**Memorandum
Department of Planning & Public Works**

RE: **P.Z. 29-2006 Wildhorse Bluffs (Wildhorse Partners LLC):** A request for a change of zoning from a "NU" Non-Urban District to an "E-One Acre" Estate District with a "WH" Wild Horse Creek Road Overlay for an approximately 4.9 acre tract of land located north of Wild Horse Creek Road and west of Long Road.

Planning Commission Staff Report

Petition: P.Z. 29-2006 Wildhorse Bluffs (Wildhorse Partners, LLC)

**WIND HORSE BLUFFS
PRELIMINARY SITE DEVELOPMENT PLAN**
Prepared For:
ICG INC.
1600 HERITAGE LANDING, SUITE 112
ST. CHARLES, MO 63303
314.406.3621
122 N. Kirkwood Road
Kirkwood, MO 63122
Tel: 314.952.6286
Fax: 314.952.7592
Email: wind@windengr.com

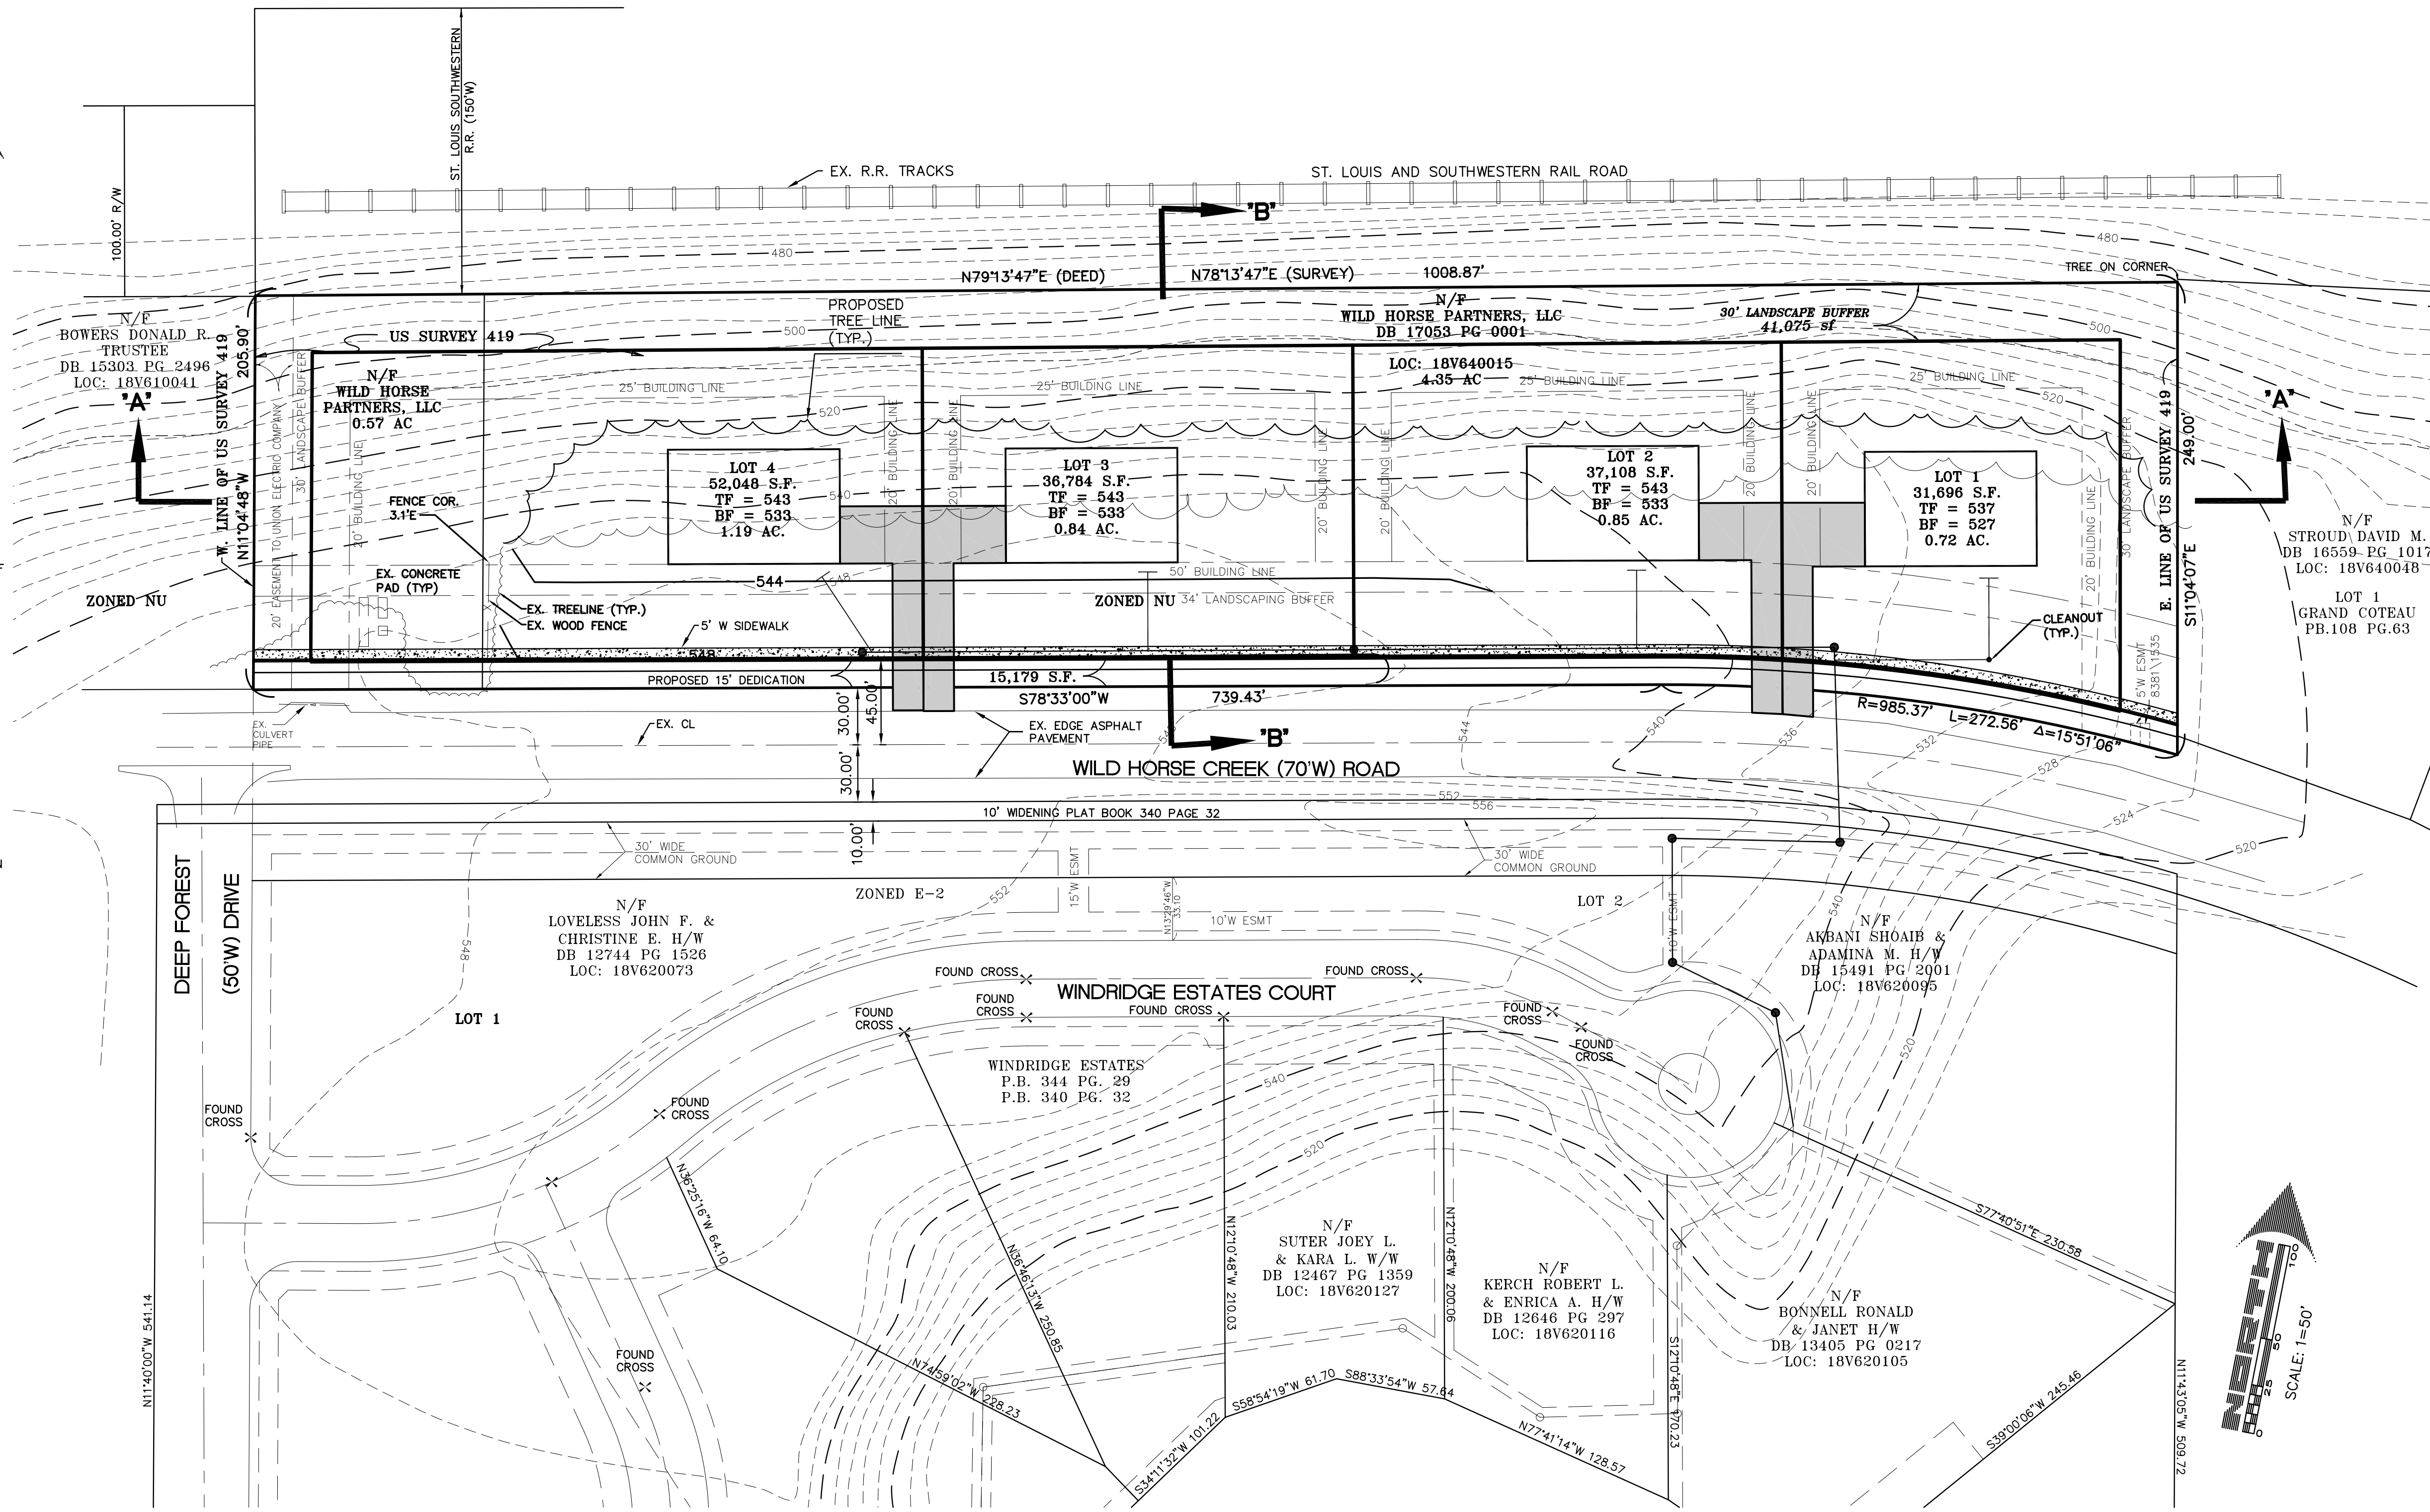
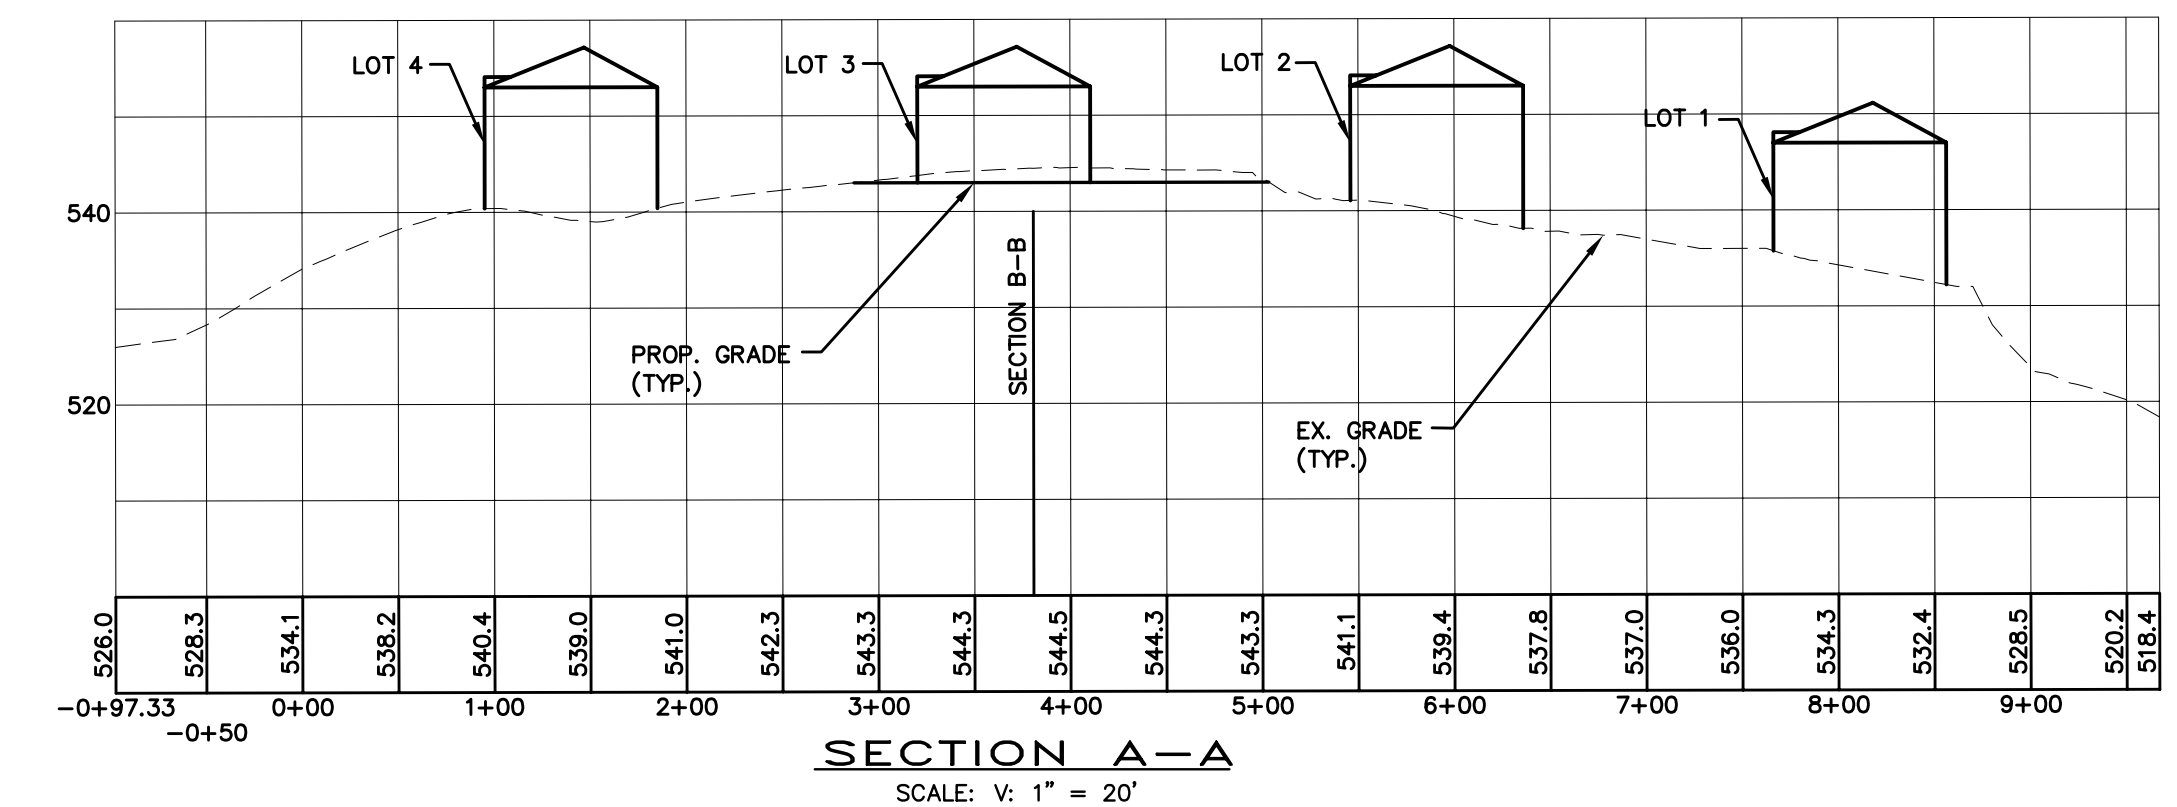
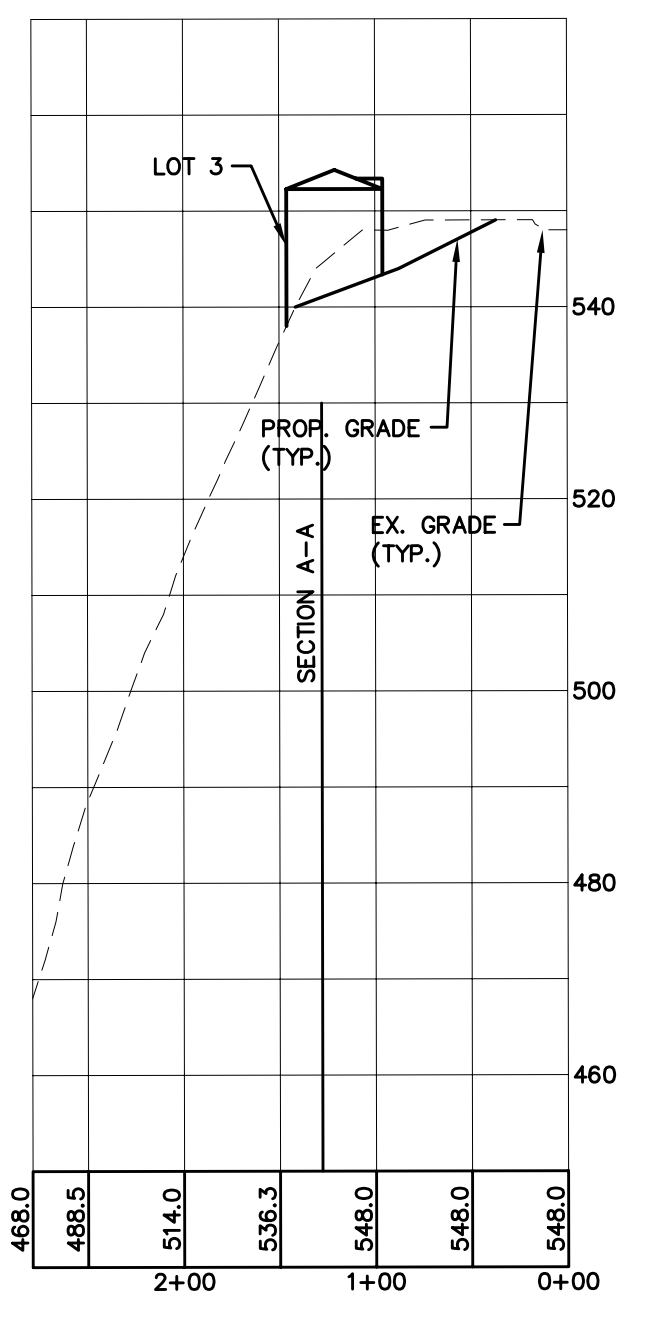
1. Will the monarch tree labeled number 83, on the Tree Stand Delineation submitted on November 29, 2006, be saved?

2. The Tree Stand Delineation referenced above shows a tree labeled 83A on the plan but the same tree is not listed in the tree inventory. Please clarify.

3. How long are the shared driveways?

5. How feasible is it to change the two shared driveways into one shared driveway for the four houses?

8. Provide a 30 foot landscape buffer around the perimeter of the development.

9. Per City of Chesterfield Ordinance 2275 buffers shall not count toward lot size. Please provide new lot size calculations.

10. Provide a sidewalk per City of Chesterfield Ordinance 2275.

11. Per City of Chesterfield Ordinance 2275 an 80 foot structure setback from Wild Horse Creek Road is required.

12. How much of the development will be built on the bluffs?

13. Be advised that City of Chesterfield Ordinance 2275 requires that 70% of all areas exceeding a 30% slope shall be protected and shall remain without development.

16. Visibility may be an issue for this development as far as access onto Wildhorse Creek Road. A sight distance study will be required to analyze sight lines and viability of the driveways as they are proposed.

It is the developer's intention to preserve this tree.

The arborist tells us this tree is a hard maple.

From the curb line, each of the shared driveways is approximately 80 feet in length.

This change is not feasible.

Consistent with our discussions at the end of January, there will be no landscape buffer on the north side of the development that faces the sharp topographical decline and the Airport. The other three sides of the development will have the landscape buffer as required.

I understand these are included in the new plans you received about two weeks ago.

This detail is included in the new plans.

According to the Planning Department's interpretation of the ordinances, a combination of a fifty-foot setback and a thirty foot setback would be required. From the outset of this proposal, however, we informed the City that we needed an exception to this rule that would recognize the fifty foot setback but not the additional thirty feet. Before this proposal was even filed with the City we met with the two members of the City Council who represent this area. Immediately after filing, we met with the planning staff. At all times this difficulty was known. It has been consistently acknowledged by all parties that the exception is required by the topography of the site, and that therefore, our request for an exception is not based on mere convenience or to seek to maximize density. We continue to anticipate the necessity of such an exception.

The rear 25 feet of the houses on lots 3 and 4 will minimally impact the bluff.

The bluff is the only part of the property with a slope of 30% or greater. The impact as described in response to issue #12 is to only 10% of the bluff, leaving 90% protected.

MODOT has approved and authorized that present plan. Because Wild Horse is a state road, the developer contends that this approval satisfies all requirements with regard to the development.
